TRI-PARTY AGREEMENT

Change Notice Number TPA-CN- 622	TPA CHANGE NOTICE FORM	Date: April 3, 2014
Document Number, Title, and Revision: DOE/RL-2009-124, 200 West Pump and Treat Operations and Maintenance Plan, Revision 2		Date Document Last Issued: November 2013
Originator: Bob Cathel		Phone: 373-9171

Description of Change:
Revision of DOE/RL-2009-124, Appendix B, Waste Management Plan for the 200 West Pump and Treat to allow storage of IDW at a centralized location near B6269 5-Bay area.

Figure B-5. Centralized Waste Storage Area

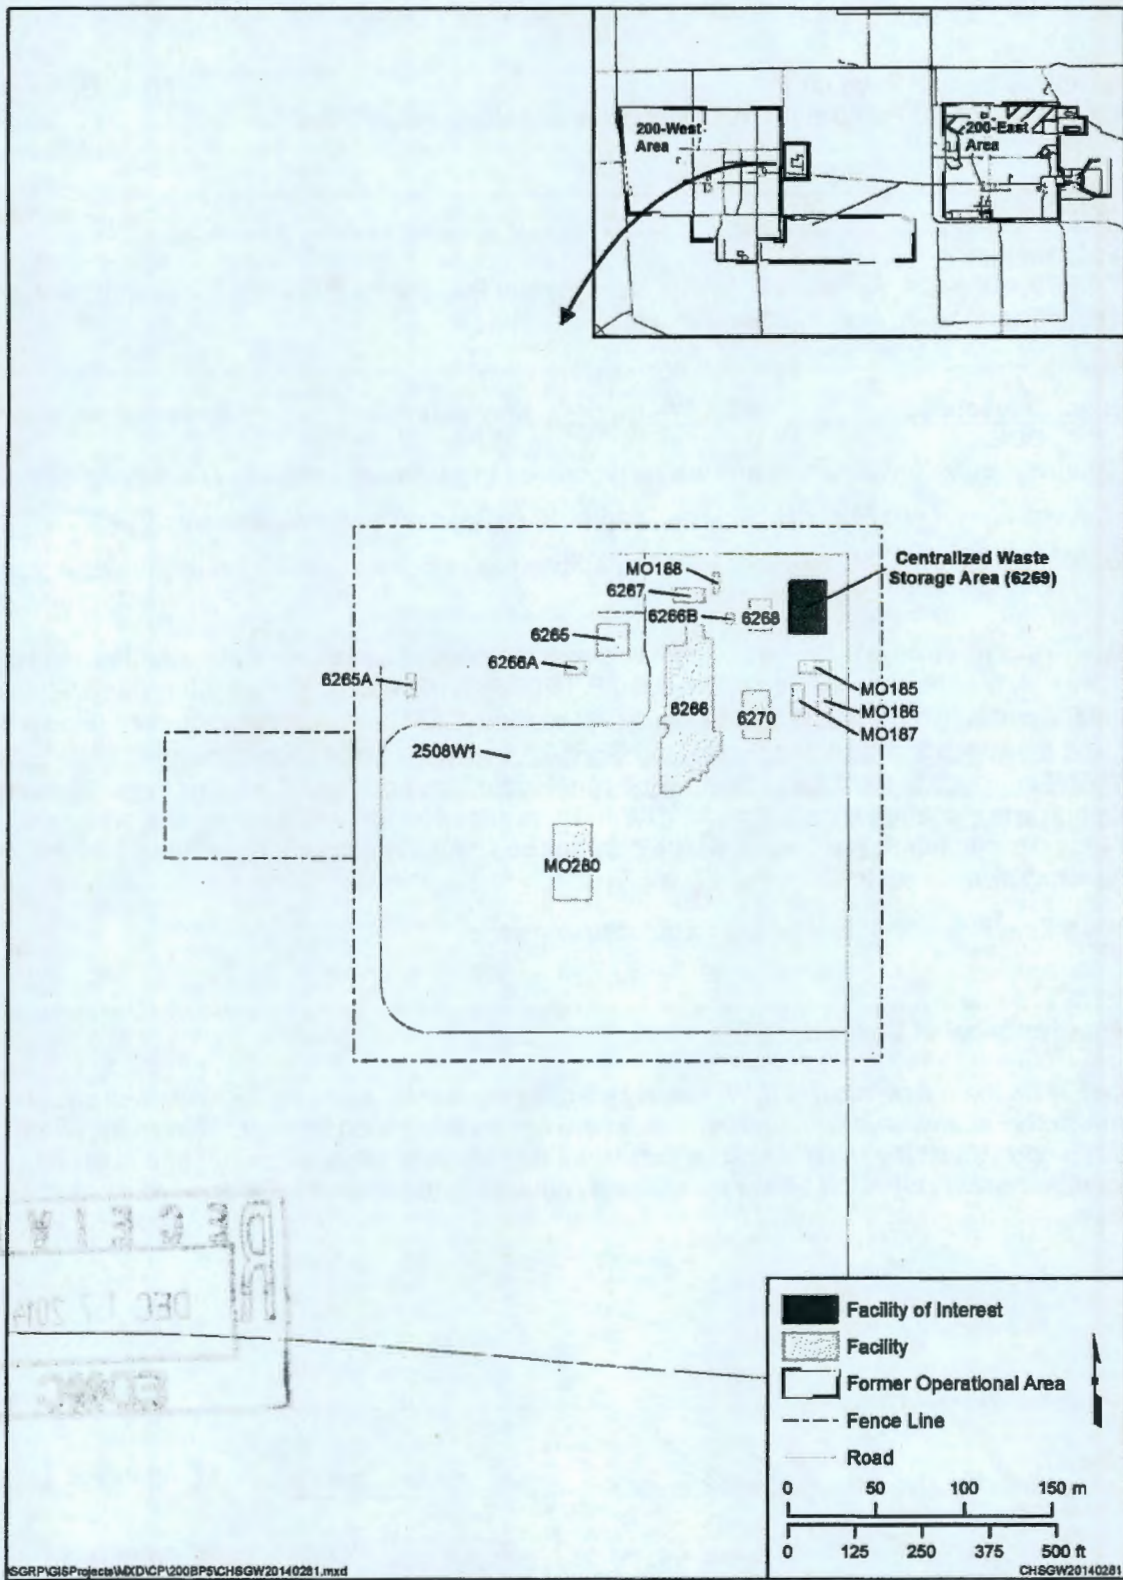
Page B-9, Section B3.3, Waste Storage, is changed by adding Figure B-5 and adding the double underlined text, as follows:

The IDW waste (e.g., drill cuttings) may be accumulated near the point of generation while awaiting analytical laboratory test results. IDW may also be accumulated at the 200-ZP-1/200-PW-1/200-UP-1 consolidated *Comprehensive Environmental Response, Compensation, and Liability Act of 1980 (CERCLA)* waste storage area (Figure B-4). Additionally, IDW may be managed at the centralized CERCLA waste storage area near building 6269 5-Bay (5-Bay area) (Figure B-5). IDW managed at the 5-Bay area may be consolidated, as appropriate, irrespective of operable unit origin, to facilitate efficient waste management practice. If IDW must be stored for longer than 6 months after designation, concurrence from the lead regulatory agency will be obtained on storage, treatment, and disposal options of the waste along with the disposition schedule.

The referenced figure "Figure B-5" is included on the following page.
